# SAFETY RECALL BULLETIN

| SUBJECT:   |   |  | No: <b>SR-21-007REV3</b>                          |
| <b>SEAT BELT AUTOMATIC LOCKING RETRACTOR (ALR) – SAFETY RECALL CAMPAIGN - REVISION</b> |   |  | DATE: <b>January 2022</b>                         |
|  |   |  | MODEL: <b>2022 Outlander</b>                      |

**Pretensioner connector removal/install Process**

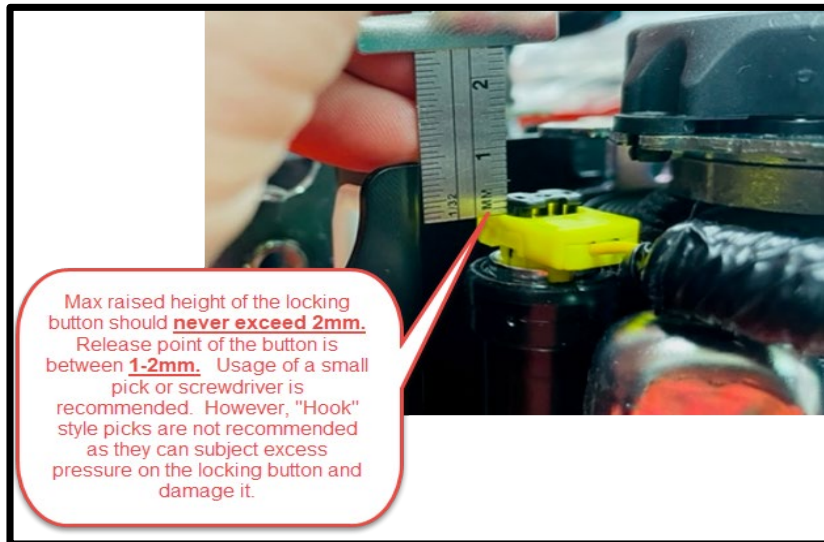
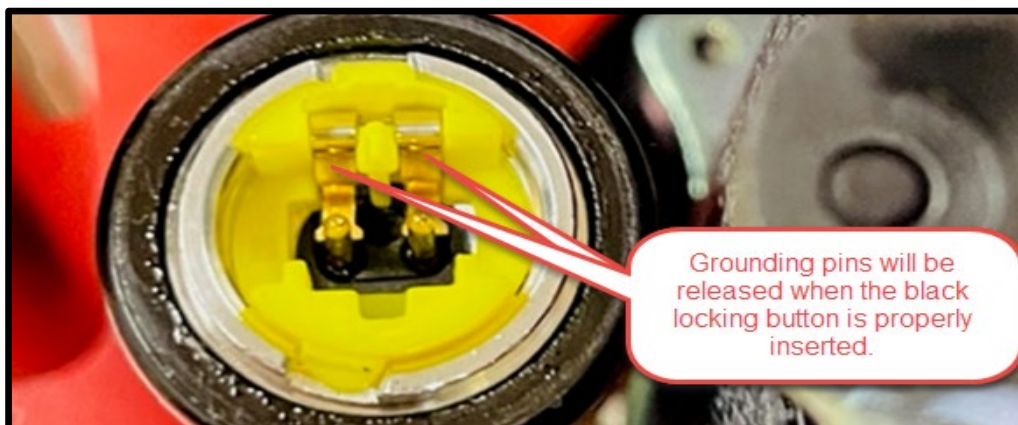
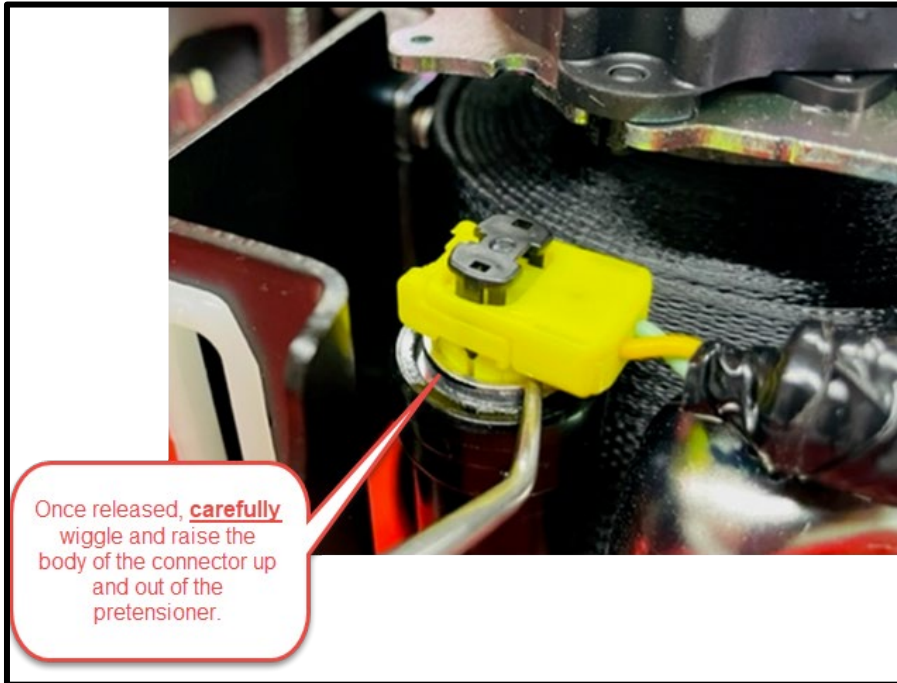
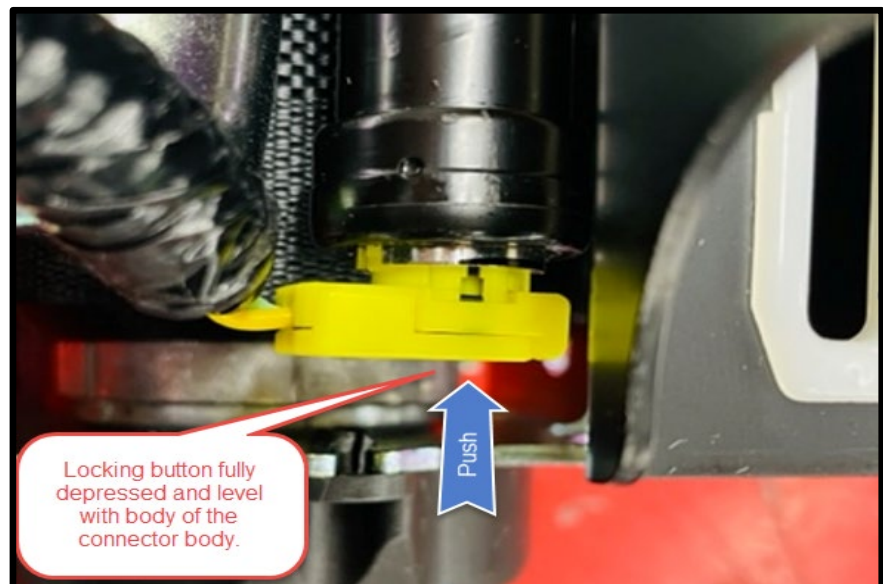
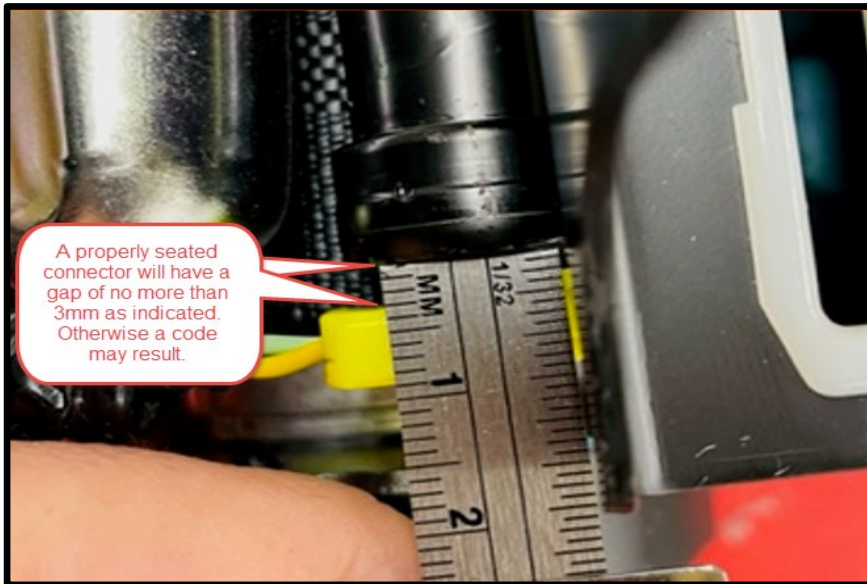
The purpose of this revision is to raise awareness to the importance of proper removal and installation of the pretensioner connector when replacing a seatbelt on a 2022 Outlander for Recall SR-21-007. Please see pages 11 - 13 and page 16 of this recall bulletin for additional information. Revisions are italicized and indicated by: ◀

Failure to follow proper procedure and applying unnecessary force will damage the connectors. The connectors are not available as a service part and replacement of the entire floor harness will be required. Please use the instructions below for proper removal and installation of the pretensioner connector.

1. Removal process to avoid damage.

2. Removal and inspection of connector.

3. *Proper installation and inspection.*

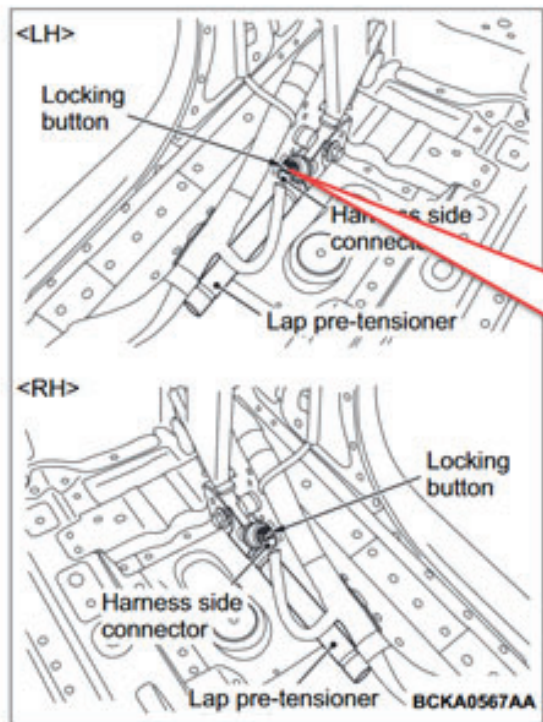
Please use **EXTRA CAUTION** when removing the locking button on the seat belt pre-tensioner connector. The locking button should only be raised approximately 1mm in an upwards direction. This will release the yellow connector body that can now be gently pulled from the pre-tensioner.

1. Use the flat-tipped screwdriver to pull out the locking button of wiring harness side connector, and release the lock.

**USE EXTREME CARE TO AVOID DAMAGE** when releasing the black locking button. **DO NOT ATTEMPT TO REMOVE COMPLETELY!** The locking button is only designed to be raised approximately 1mm which permits removal of the connector.
